City of Columbia
ARCHITECTURAL DESIGN REVIEW TEAM
December 12, 2023

Request from Greg Gamble for new construction façade approval within a Planned Unit Development at 400 Bear Creek Pike.

PROJECT DESCRIPTION: Façade Design Approval for Single-Family Homes, Townhomes, Amenity Ares, and Daycare Facility

Architectural Review Team Submittal

DAYCARE ELEVATIONS

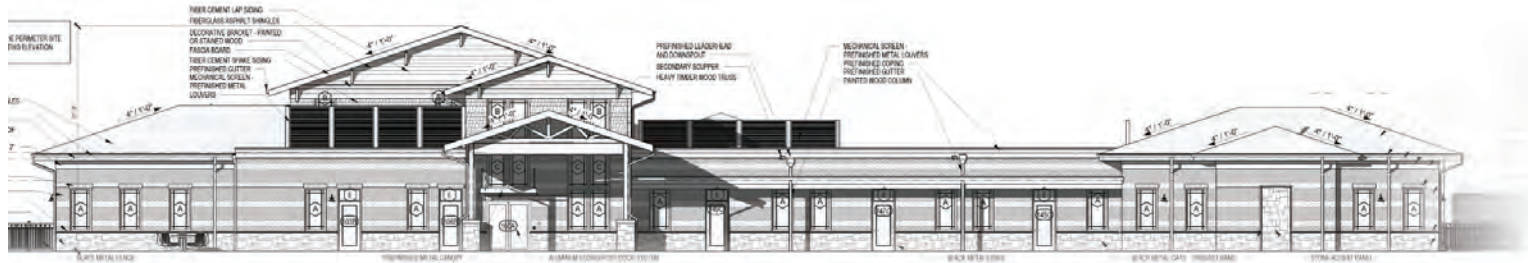
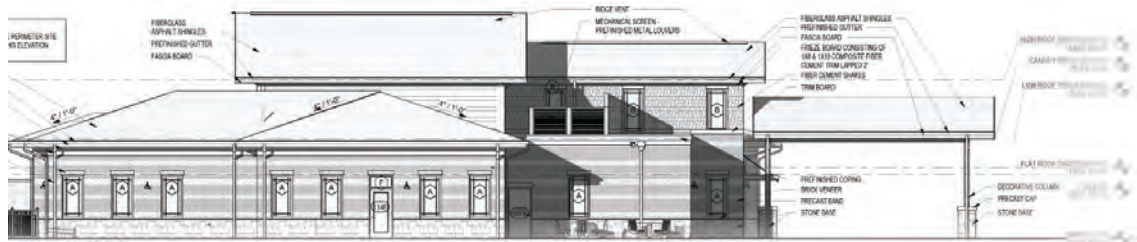
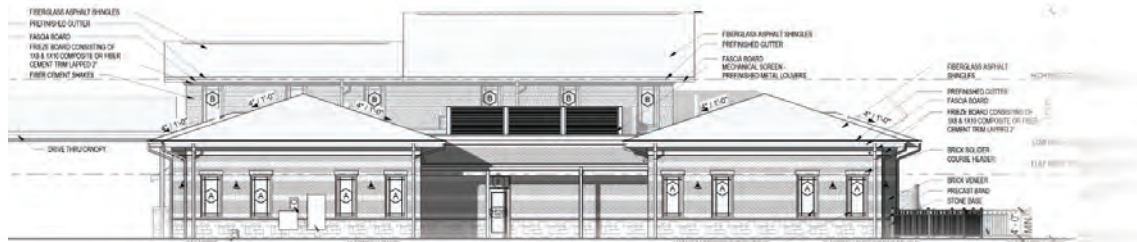
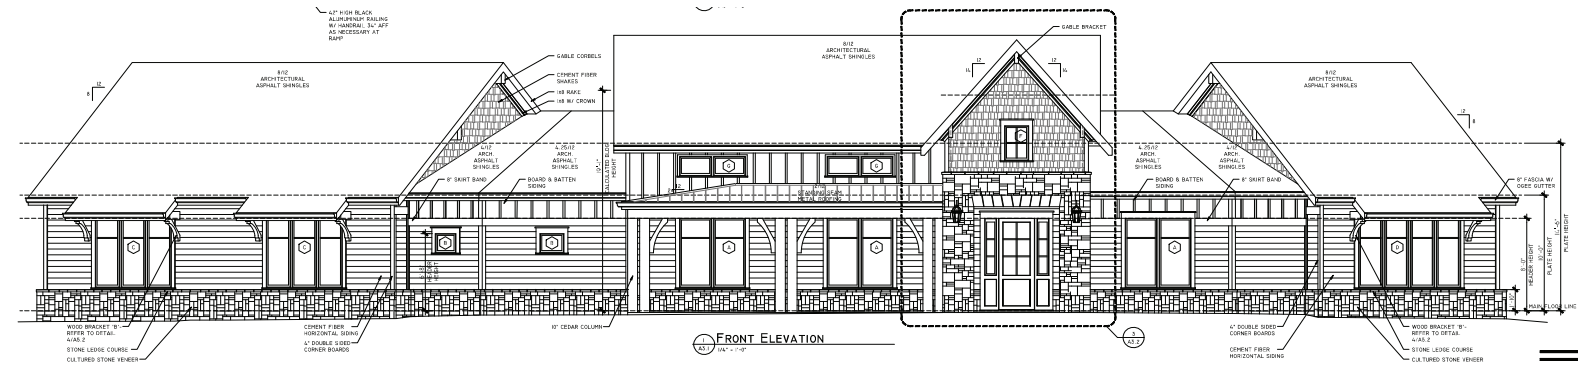
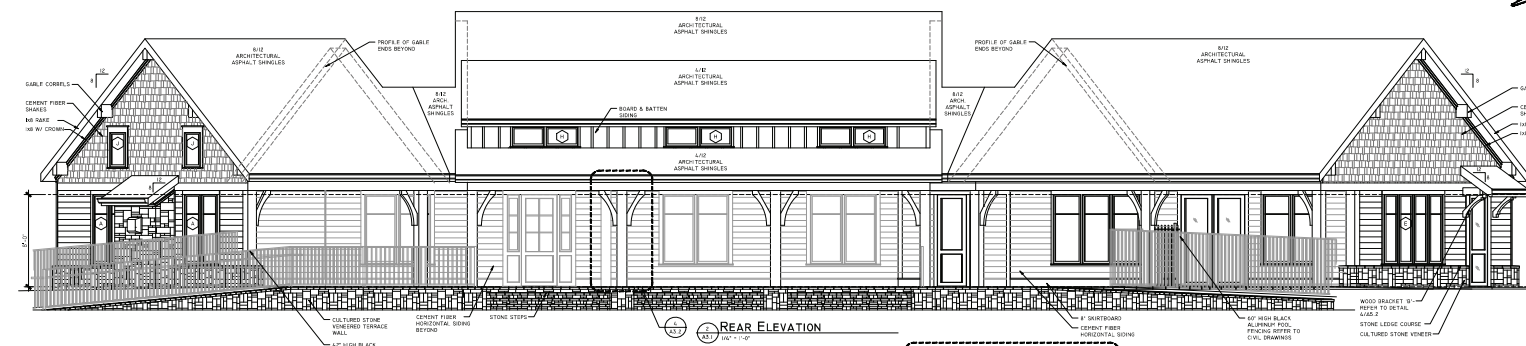
(PUD R) District Standards : Day Care Facility		
Design Standards:	Required	Proposed
Vertical Composition:	Identifiable Base, Middle, & Cap	All structure indicates a defined base, middle, and cap.
Finished Floor Elevation:	Min 18 inches above finished grade	Details of the FFE were not given
Façade Position & Façade Articulation:	Main entrance at façade & position parallel to frontage line	The proposed daycare enfronts a proposed street section with entrance.
Façade Openings:	20 ft. or less spacing for windows/doors	All windows appear to be 20 ft or less with no blank facades
Façade Glazing:	20-60 % (70% glazing for shopfront elevation)	Shopfront elevation does not indicate 70 percent glazing requirement.
Window Shape:	Square or vertical proportions	All windows are square or vertical proportioned.
Window Alignment:	Upper floor windows and other features must be aligned with those of first floor	All windows align with those on the first floor.

Window Types:	Single-hung, double-hung, casement except in shopfront or galley	Windows appear to be fixed glass at all elevations
Window Glazing Material:	Clear	All windows proposed are clear glass.
Window Trim in 1st Layer:	Min 4 in. trim with sill and top plate/ soldier course above lintel and rowlock course below sill	Elevations appear to consist of window trim details and rowlock course below window sills and soldier course above windows for brick elevations.
Shutters:	Functional to cover half of window width/ shutter dogs	N/A
Façade Window Sill Height:	5 ft. min above grade	Details were not given on façade window sill height 5' min above grade.
Porch Frontages:	Min. 6ft. clear depth, excluding rails, pillars, columns	N/A

Façade Variety:	No façade may exist more than once on a block face or within view of same façade	This use proposed is a single site use that consist of one façade.
Roof Type & Pitch:	Hip/ Gable	Roof type & pitch proposed is hip & gable
Primary Building Materials:	Brick, Fiber Cement Board, Wood	Elevations consists of a primary façade material of brick with a stone base including fiber cement board
Foundation Cladding:	Brick or Natural Stone	Foundation cladding indicated is stone
Porch Pier/ Chimney Cladding:	Brick or Natural Stone & any space under porch concealed by lattice/ brick or natural stone for chimney	Porch piers indicate a stone base
Building Height:	2 Stories min- 4 stories max	2 stories

DAYCARE ELEVATIONS

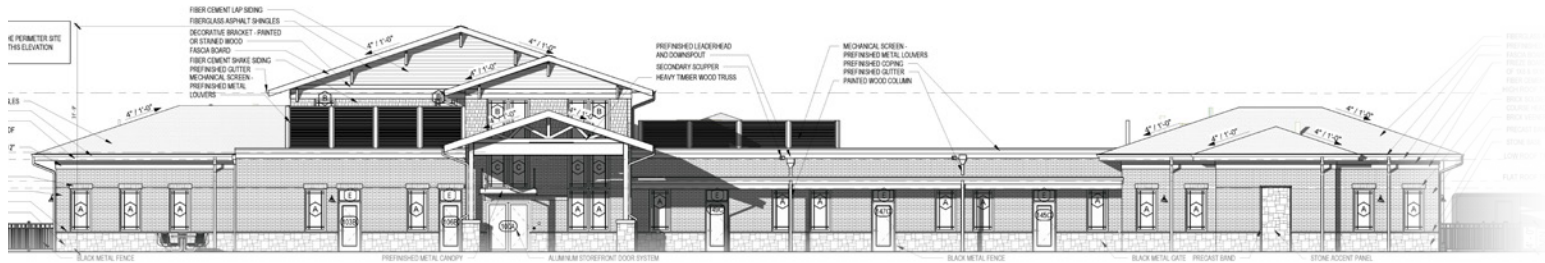
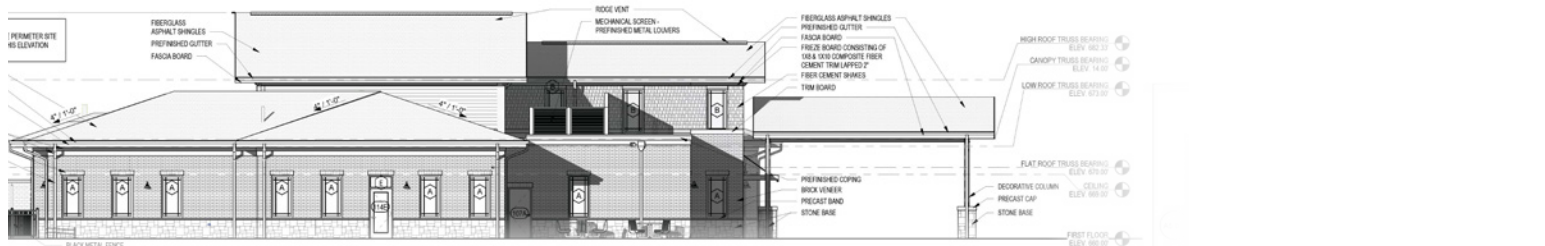
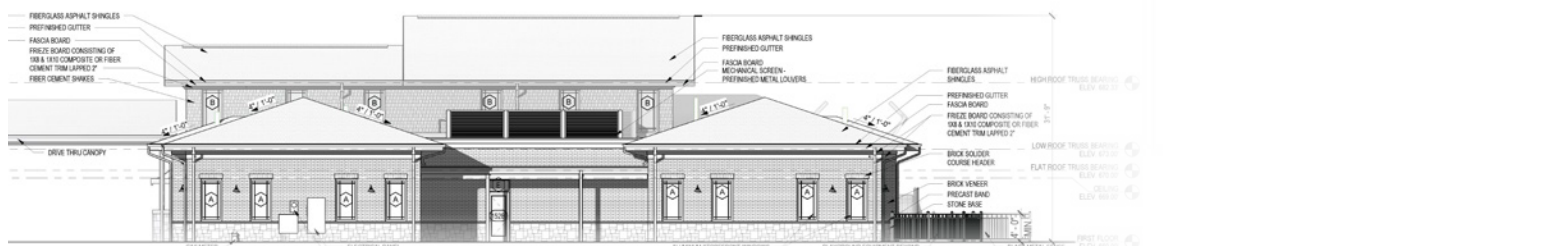
(PUD R) District Standards : Day Care Facility		
Design Standards:	Required	Proposed
Vertical Composition:	Identifiable Base, Middle, & Cap	All structure indicates a defined base, middle, and cap.
Finished Floor Elevation:	Min 18 inches above finished grade	Details of the FFE were not given
Façade Position & Façade Articulation:	Main entrance at façade & position parallel to frontage line	The proposed daycare enfronts a proposed street section with entrance.
Façade Openings:	20 ft. or less spacing for windows/doors	All windows appear to be 20 ft or less with no blank facades
Façade Glazing:	20-60 % (70% glazing for shopfront elevation)	Shopfront elevation does not indicate 70 percent glazing requirement.
Window Shape:	Square or vertical proportions	All windows are square or vertical proportioned.
Window Alignment:	Upper floor windows and other features must be aligned with those of first floor	All windows align with those on the first floor.

Window Types:	Single-hung, double-hung, casement except in shopfront or galley	Windows appear to be fixed glass at all elevations
Window Glazing Material:	Clear	All windows proposed are clear glass.
Window Trim in 1st Layer:	Min 4 in. trim with sill and top plate/ soldier course above lintel and rowlock course below sill	Elevations appear to consist of window trim details and rowlock course below window sills and soldier course above windows for brick elevations.
Shutters:	Functional to cover half of window width/ shutter dogs	N/A
Façade Window Sill Height:	5 ft. min above grade	Details were not given on façade window sill height 5' min above grade.

Porch Frontages:	Min. 6ft. clear depth, excluding rails, pillars, columns	N/A
Façade Variety:	No façade may exist more than once on a block face or within view of same façade	This use proposed is a single site use that consist of one façade.
Roof Type & Pitch:	Hip/ Gable	Roof type & pitch proposed is hip & gable
Primary Building Materials:	Brick, Fiber Cement Board, Wood	Elevations consists of a primary façade material of brick with a stone base including fiber cement board
Foundation Cladding:	Brick or Natural Stone	Foundation cladding indicated is stone
Porch Pier/ Chimney Cladding:	Brick or Natural Stone & any space under porch concealed by lattice/ brick or natural stone for chimney	Porch piers indicate a stone base
Building Height:	2 Stories min- 4 stories max	2 stories
